DEVIATION REQUEST AND DECISION FORM

Project Name : **Retreat at PrairieRidge Filings 1-3 Preliminary Plan**

A deviation from the standards of the ECM in **Chapter 2.3.7.D.2, 2.3.7.D.3, 2.2.4.B.2, 2.2.5.B and Table 2-6** is requested.

| RETREAT AT PRAIRIERIDGE FILINGS 1-3 PRELIMINARY PLAN FILING 1 & 2 | | | |

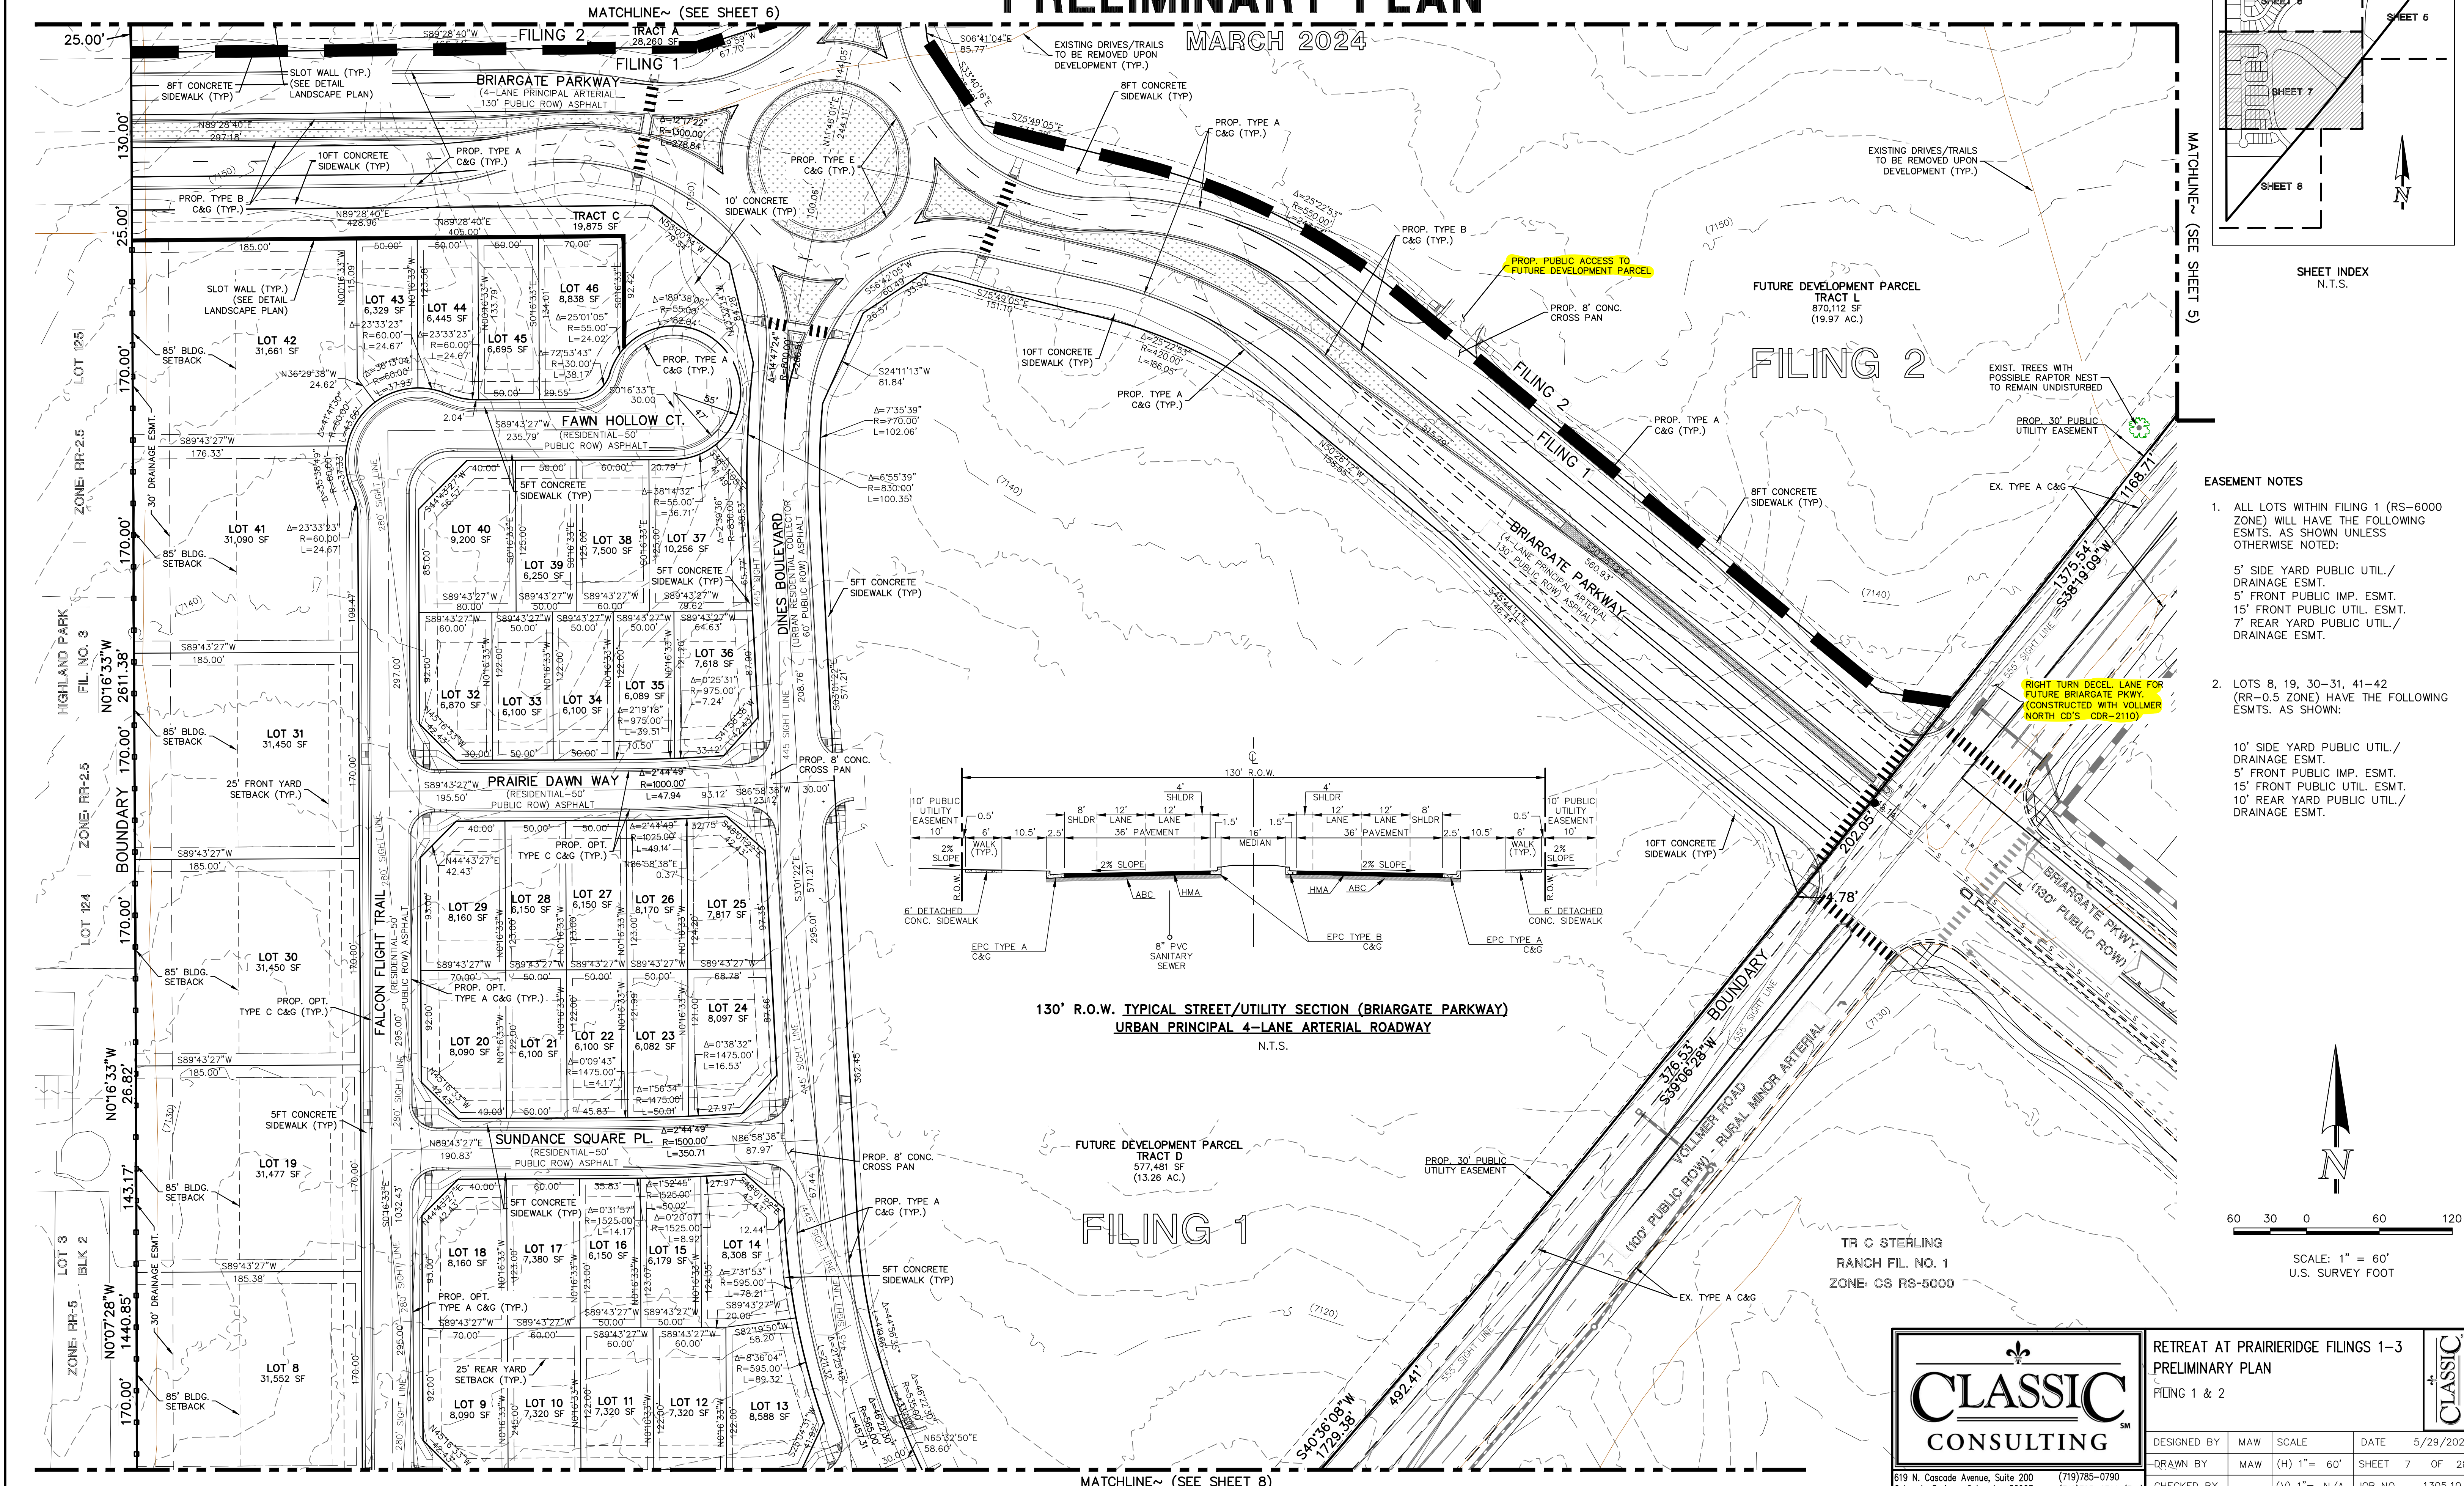
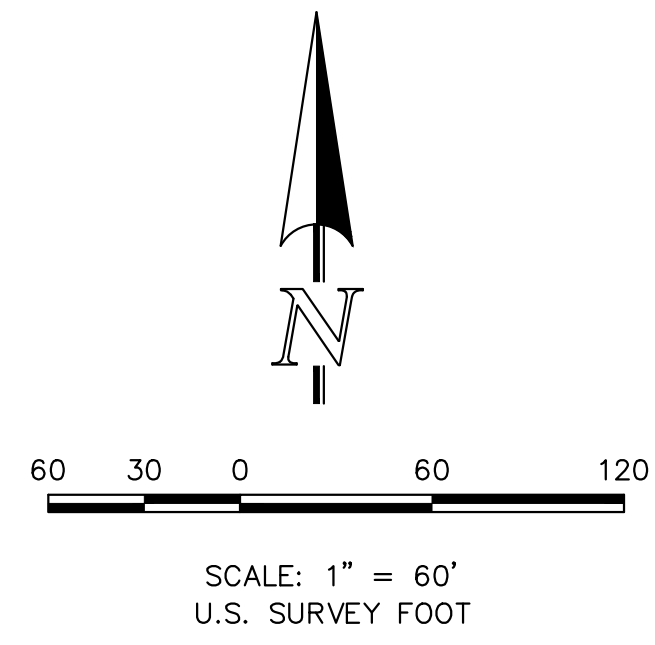
No acceleration lane proposed for west-bound Briargate Pkwy. at Vollmer Road
Intersection spacing less than ½ mile on Briargate Pkwy. between Vollmer Road and round-about
Proposed direct lot access (RI/RO) from Briargate Pkwy. and (RI only) from Vollmer Road into future Commercial site

Acceleration lane on west-bound Briargate Pkwy. in combination with the proposed right turn lane into the commercial site would likely cause some unwanted traffic weaving. The intersection of Briargate Pkwy. and Vollmer Road will eventually be signalized to allow for gaps in traffic. The posted speed limit on west-bound Briargate Pkwy. approaching the round-about will most likely be reduced to 40 mph or less.

Due to topographic and planning constraints, the future commercial site will only have access ability from Briargate Pkwy. and Vollmer Road. Given the natural grade across this portion of the site, there will be a significant vertical difference between the future PUD residential and the future commercial. The commercial site is planned to be about 12' lower in elevation than the PUD residential site. This grade difference will be made possible by a retaining wall and no roadway access between the two parcels. The proposed direct access to Briargate Pkwy. was also shown on the approved Jaynes Property Sketch Plan.

The proposed alternative is to provide a right turn deceleration lane on west-bound Briargate Pkwy. into the commercial site and a two-lane urban round-about approximately 1000 LF west of the Vollmer intersection, both as presented on the approved Jaynes Property Sketch Plan. A Right-In only with required deceleration lane from Vollmer Road into the commercial site is also proposed, similar to the same access type directly across Vollmer into the Homestead North Filing No. 1 subdivision.

This request has been determined to have met the criteria for approval. A deviation from Chapter 2.3.7.D.2, 2.3.7.D.3, 2.2.4.B.2, 2.2.5.B and Table 2-6 of the ECM is hereby granted based on the justification provided.
